CP-200800263  
Log # TXX-08031

**SUBJECT:** COMANCHE PEAK STEAM ELECTRIC STATION  
DOCKET NOS. 50-445 AND 50-446  
SUPPLEMENT TO LICENSE AMENDMENT REQUEST (LAR) 07-004  
REVISION TO THE OPERATING LICENSE AND TECHNICAL SPECIFICATION 1.0,  
"USE AND APPLICATION" TO REVISE RATED THERMAL POWER FROM 3458 MWT  
TO 3612 MWT. (TAC NOS. MD6615 AND MD6616)

## **RESPONSE TO REQUEST FOR ADDITIONAL INFORMATION**

CPSES EMERGENCY RESPONSE GUIDELINES		UNIT 1	PROCEDURE NO. FRI-0.3A
RESPONSE TO VOIDS IN REACTOR VESSEL		REVISION NO. 8	PAGE 8 OF 44
STEP	ACTION/EXPECTED RESPONSE	RESPONSE NOT OBTAINED	
4	Establish Stable RCS Conditions:

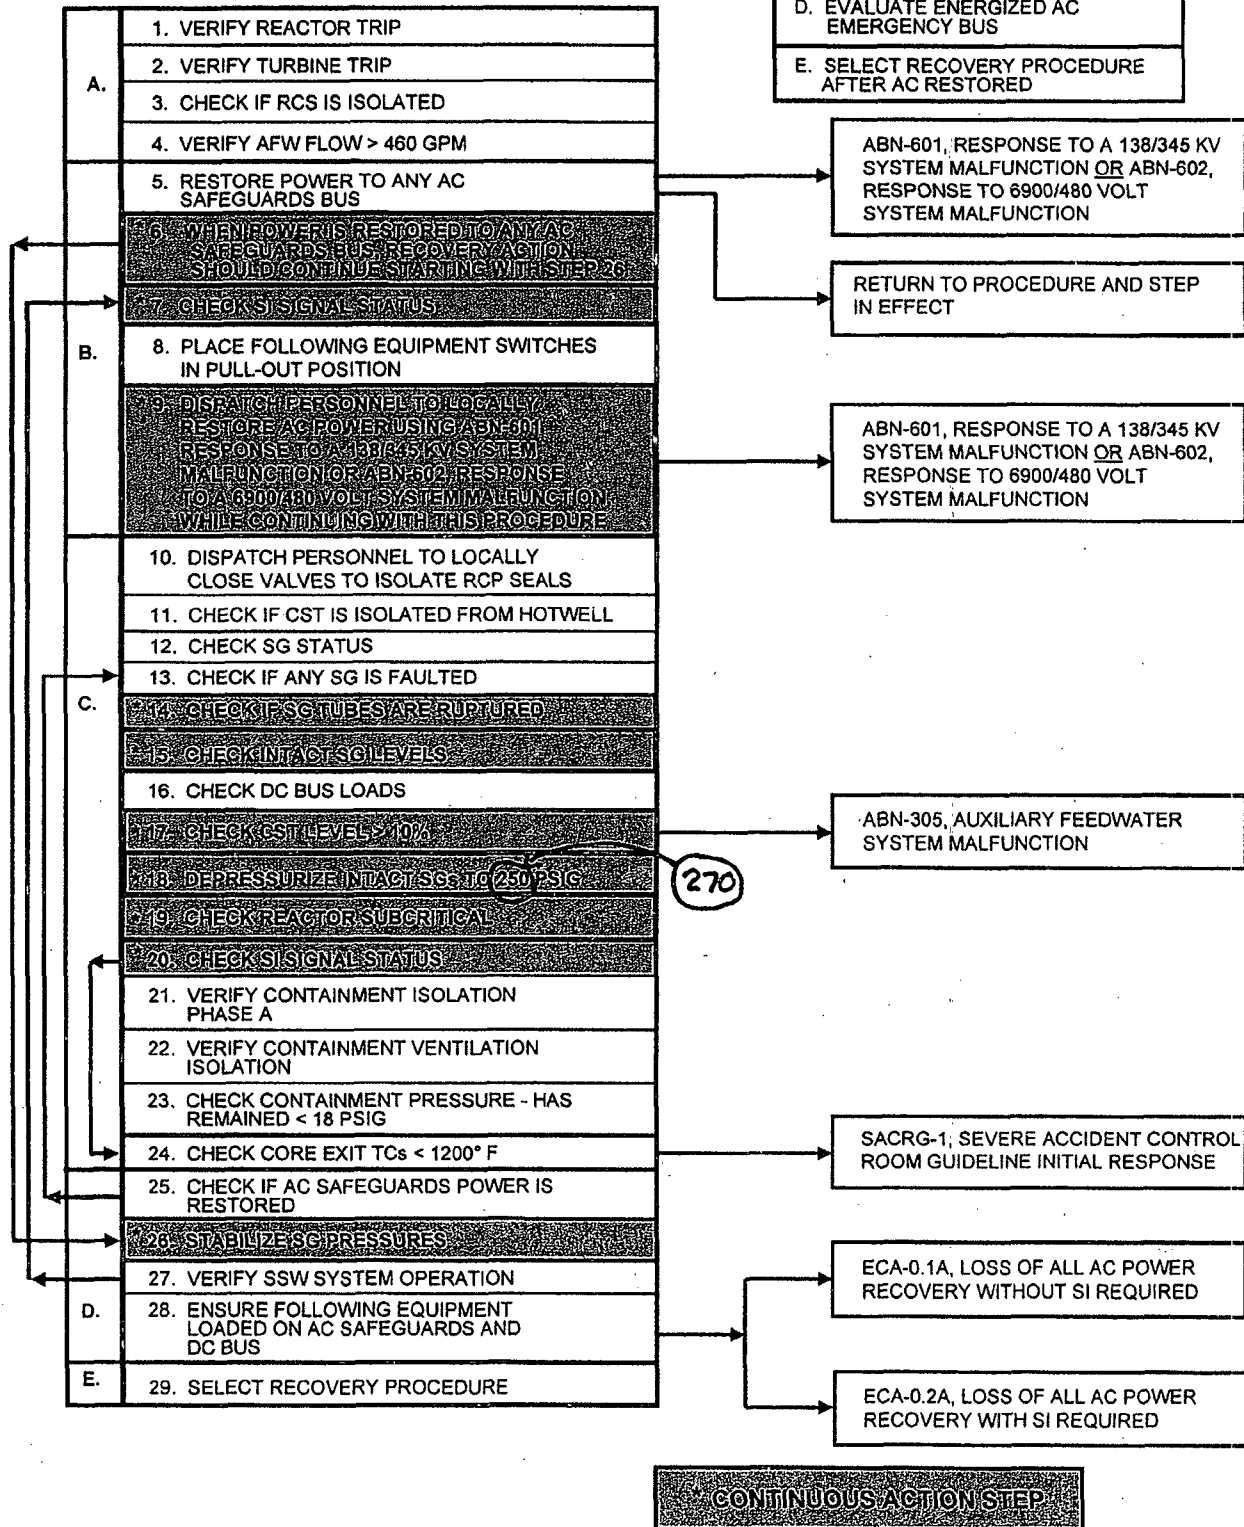
a. Pressure - AT LEAST 100 PSIG LESS THAN LIMIT OF PTLR FIGURE 2-2 (ATTACHMENT 2)	a. Go to Step 9. OBSERVE CAUTION <u>AND</u> NOTE PRIOR TO STEP 9.	
	b. Pressure - LESS THAN <u>2000</u> <u>1900</u> → <u>1875</u> PSIG <u>1975</u> PSIG FOR ADVERSE CONTAINMENT)	b. Go to Step 9. OBSERVE CAUTION <u>AND</u> NOTE PRIOR TO STEP 9.

CPSES EMERGENCY RESPONSE GUIDELINES		UNIT 2	PROCEDURE NO. FRI-0.3B
RESPONSE TO VOIDS IN REACTOR VESSEL		REVISION NO. 8	PAGE 8 OF 44
STEP	ACTION/EXPECTED RESPONSE	RESPONSE NOT OBTAINED	
4	Establish Stable RCS Conditions:

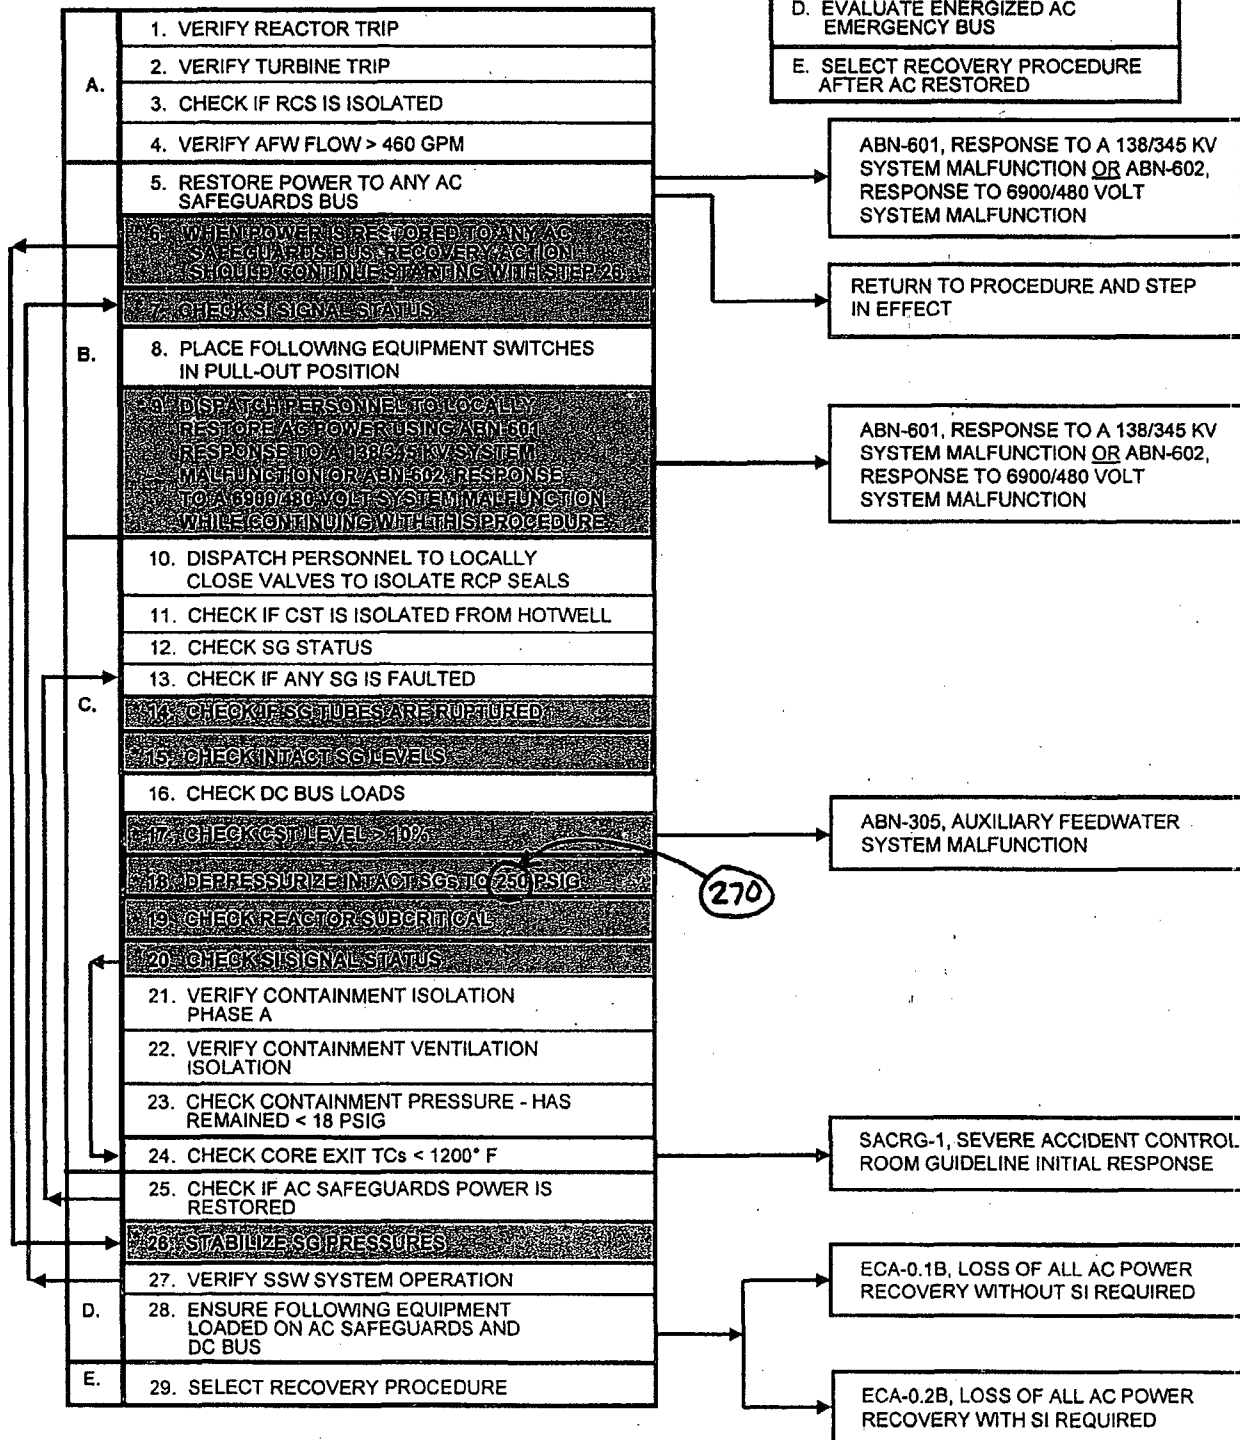
a. Pressure - AT LEAST 100 PSIG LESS THAN LIMIT OF PTLR FIGURE 2-2 (ATTACHMENT 2)	a. Go to Step 9. OBSERVE CAUTION <u>AND</u> NOTE PRIOR TO STEP 9.	
	b. Pressure - LESS THAN <u>2000</u> <u>1900</u> → <u>1875</u> PSIG ( <u>1975</u> PSIG FOR ADVERSE CONTAINMENT)	b. Go to Step 9. OBSERVE CAUTION <u>AND</u> NOTE PRIOR TO STEP 9.
